**Addendum No. 2 to the**  
**Environmental Impact Assessment**  
**(January 2016 version and First Addendum July 2016)**  
**For the**  
**Dhaka Mass Rapid Transit Development Project**

**Prepared for**  
**Dhaka Mass Transit Company**

**By NKDM**  
**April 2018**

**Figure A2 3-1: Station Roof Design**

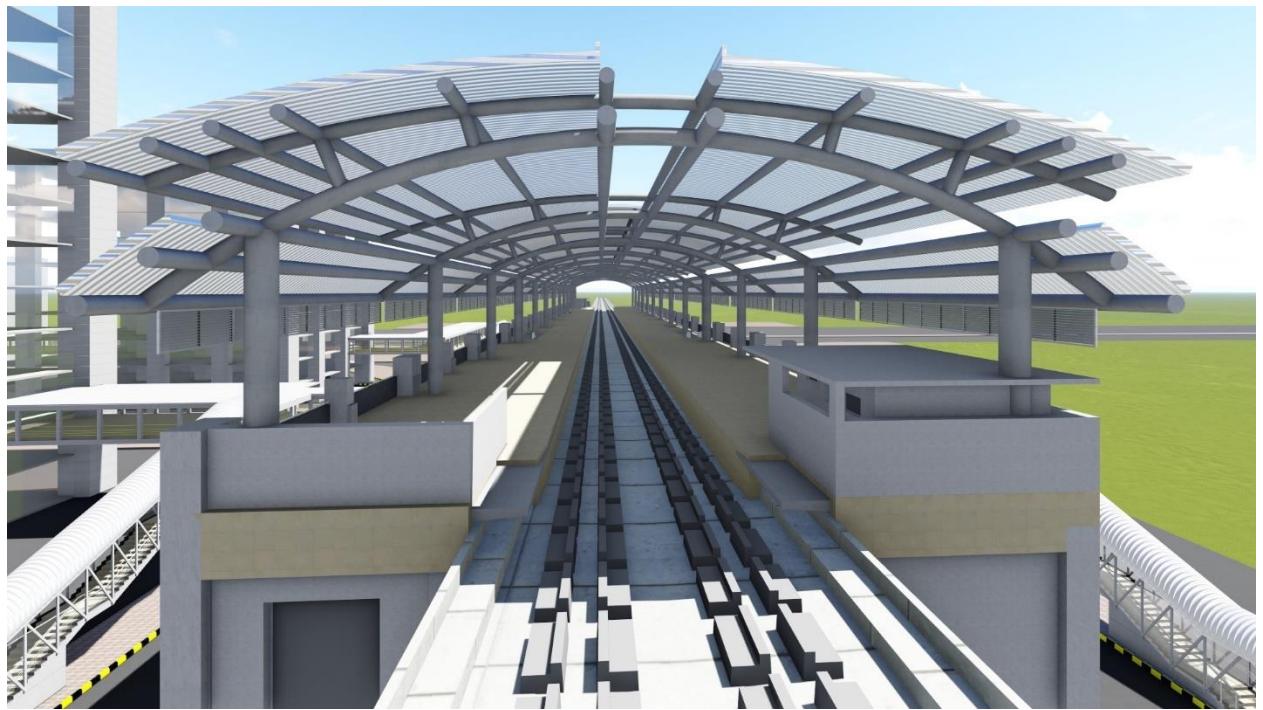
Figures contained in this section depict the architectural appearance of Motijheel, Bijoy Sharani and Uttara Center stations. Figures depicting architecture for the remaining 13 stations are as follows:

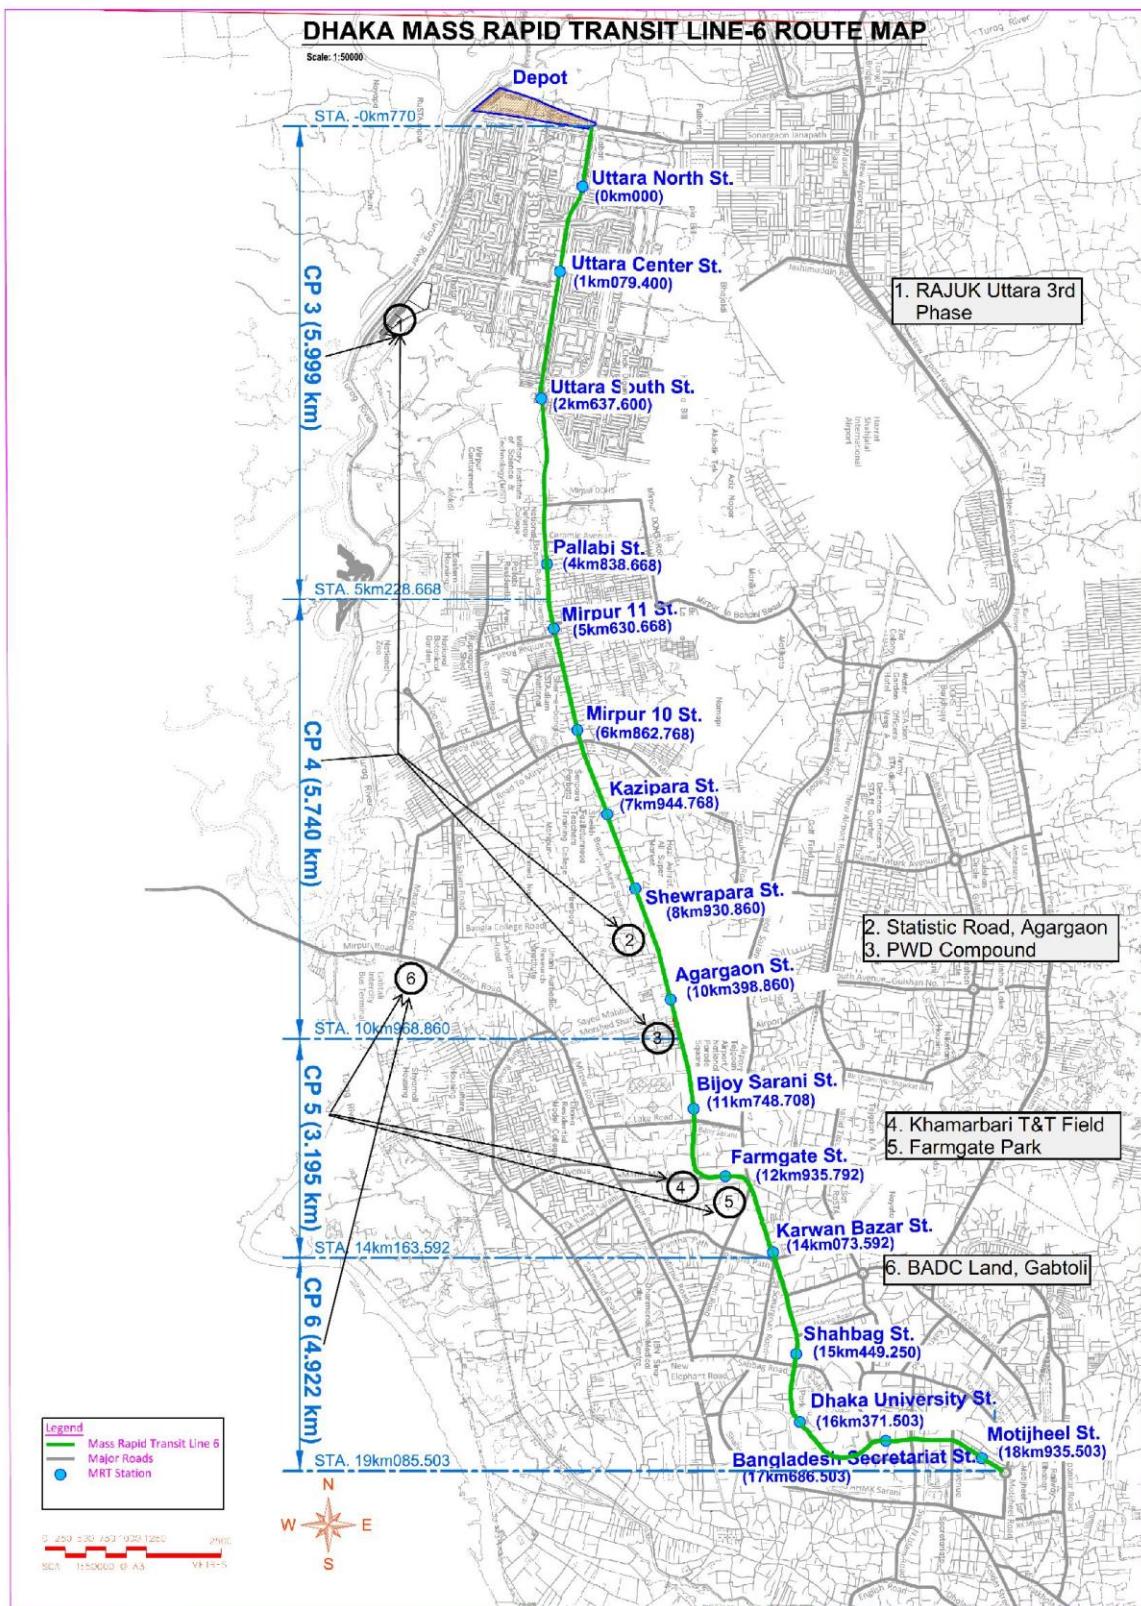
“Six locations have been identified for temporary construction facilities for use under contracts CP-3 – CP-6 (see the next section). These six sites are now confirmed, and are located as shown in Figure 3-12. Environmental aspects of these sites are evaluated in Chapter 6.”

Update Figure 3-12 contained in the EIA with the following: (next page)

Figure A2 6-1: Proposed Location for Spoil Disposal in Uttara Phase III

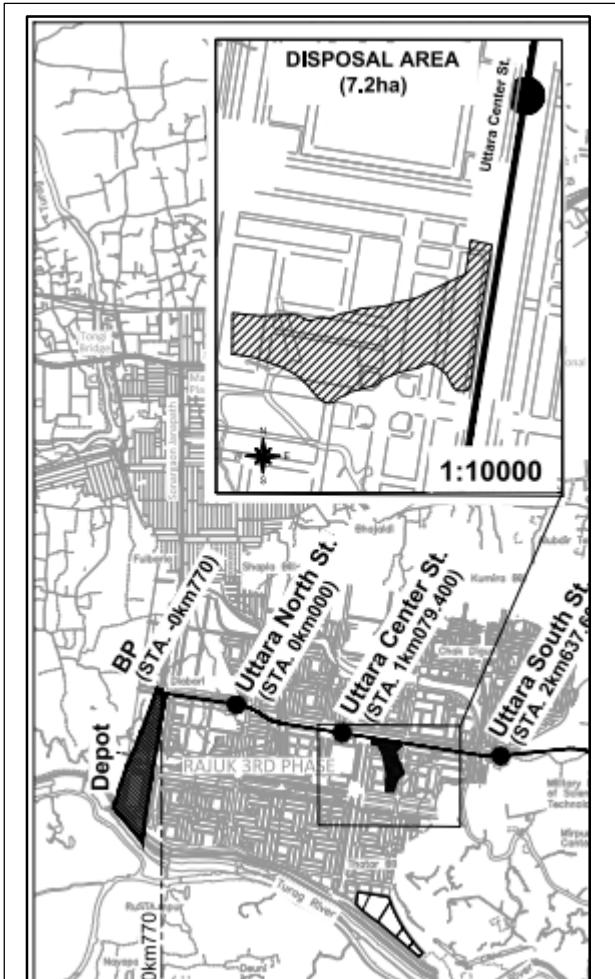
A spoil disposal area near the location for the Uttara Central Station has been identified for use by all four of the alignment contract packages (CP 3-6) (Figure A2 6-1).

The area of approx. 7.2 ha is a semi-submerged lowland slated for infilling as part of the development scheme for Uttara Phase III. Use of Class III spoil materials disposed of at the site accomplishes this purpose and is in keeping with the plan to fill the area.

Figure A2 6-2: Access Points (CP 3-6)

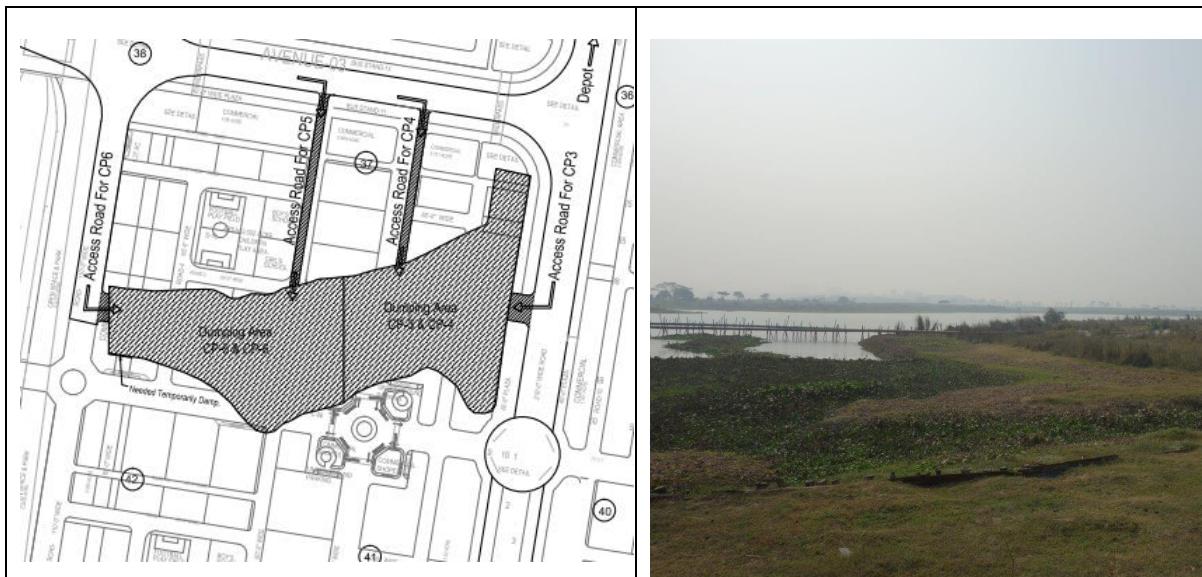
The spoil material is generated during construction of the alignment under four separate contracts. The fill will be placed progressively from four locations (one per contract) as shown in Figure A2-2. The water level in the fill area is typically low during the dry period of the year, so pumping is not required; nor is it expected that at any time the area will need to be dewatered. Rather it will be progressively filled and ponded water allowed to evaporate or seep into the ground. A view of the site is shown in Figure A2 6-3.
